March 29, 2016

Subject: Downtown Environmental Alliance, Revised Draft (redline) Technical Work Plan

Technical Work Plan – Downtown Environmental Assessment Project, Montgomery, Alabama

FIGURE 4-1
 Conceptual Site Model
 Downtown Environmental Assessment Project
 Montgomery, AL

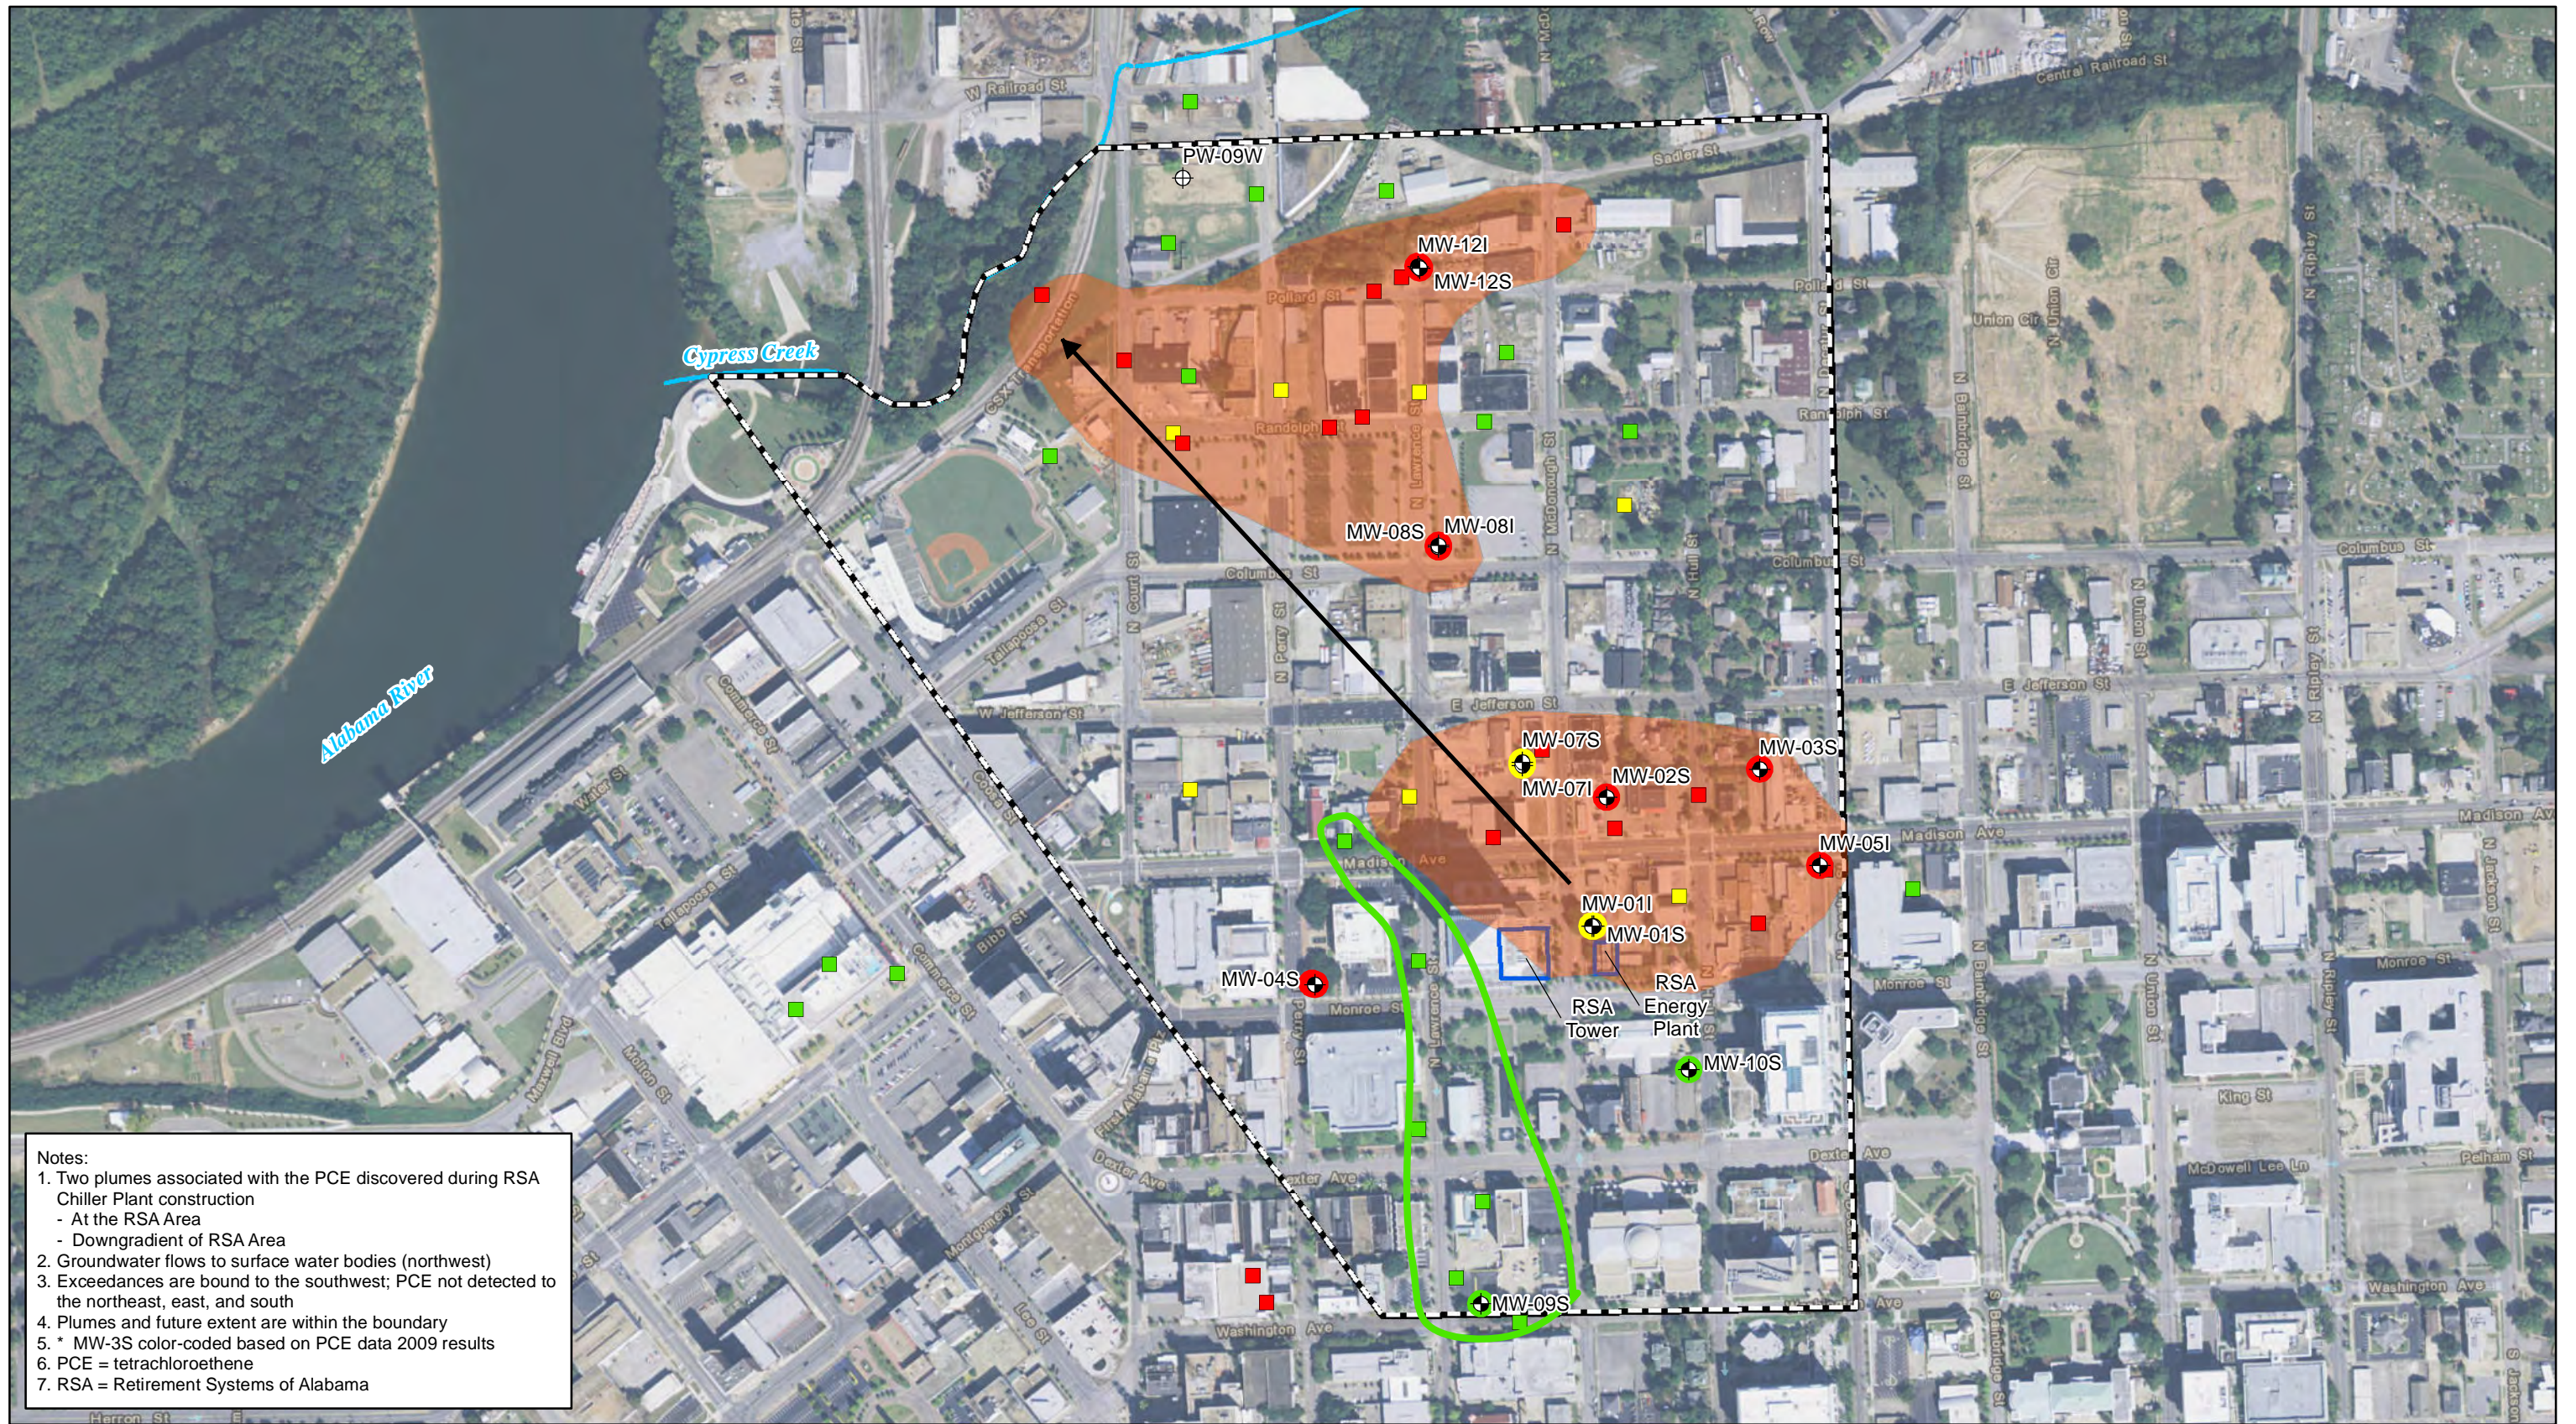
- **ADEM Comment #10 – Figure 4-1:** *Please explain why former public supply well PW-09W was not included in the northernmost tetrachloroethene (PCE) plume boundary, since this well was impacted.*

Response: Figure 4-1 was developed based on the most recent groundwater data available at each location. As indicated in the Section 4.3 text, “Plume boundaries are drawn based on locations that exceed criteria...” Available data at PW-09W (January 2014 is most recent) indicate that PCE in the well no longer exceeds the criterion. PCE was reported at 0.00084 milligrams per liter (mg/L) in January 2014, as compared to the MCL of 0.005 mg/L and latest RSL of 0.011 mg/L. The Montgomery Water Works and Sewer Board plans to permanently abandon well PW-09W in the near future. Therefore, Section 5 of the TWP and SAP was revised to remove PW-09W from the proposed groundwater sampling.

FIGURE 5-1
 Proposed Sample Locations
 Downtown Environmental Assessment Project
 Montgomery, AL

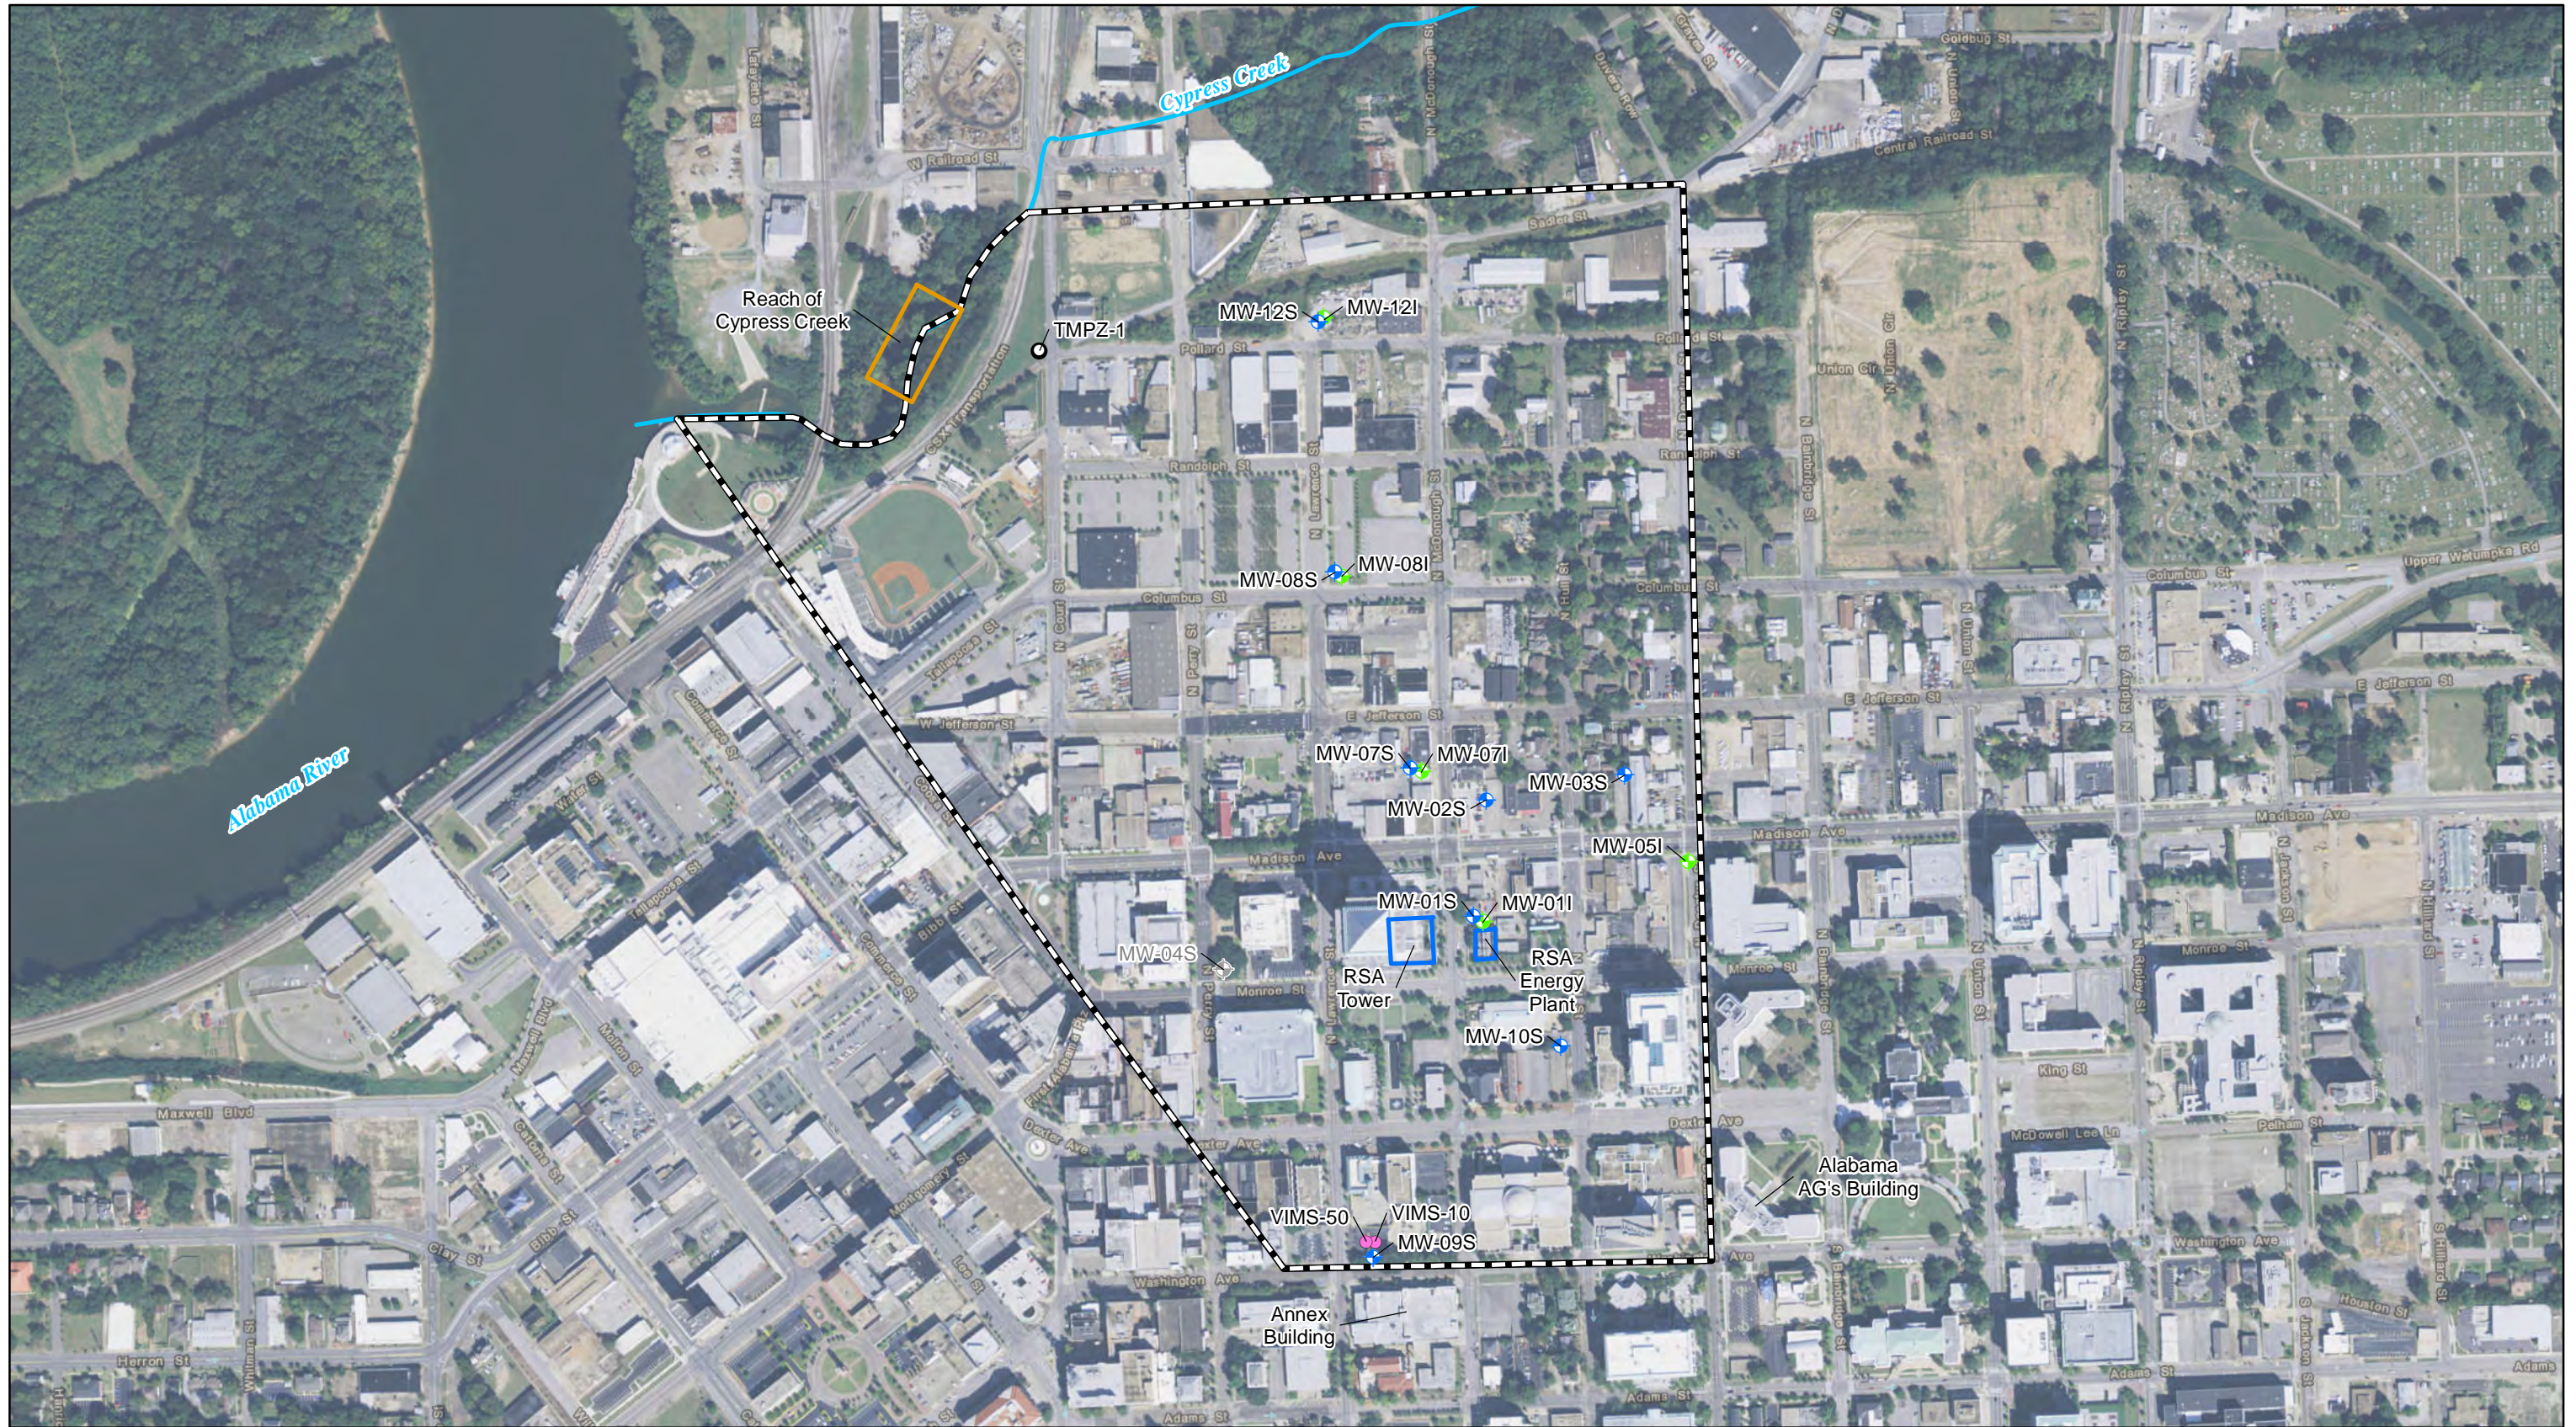
- **ADEM Comment #6 – Section 5.4:** *At least one additional piezometer should be installed approximately 20-40 feet hydraulically upgradient of proposed TMPZ-1, as site conditions dictate. This piezometer should be fitted with a transducer and monitored concurrently with Cypress Creek and piezometer TMPZ-1 to provide a needed data point to evaluate the hydraulic interaction between groundwater and Cypress Creek.*

Response: Per phone conversation with Lee Thomas on March 14, 2016, a revised location for TMPZ-1 is being proposed. Figure 5-1 has been revised to reflect the new proposed location. Based on our discussion with Mr. Thomas, this new location eliminates the need for a second location farther upgradient.
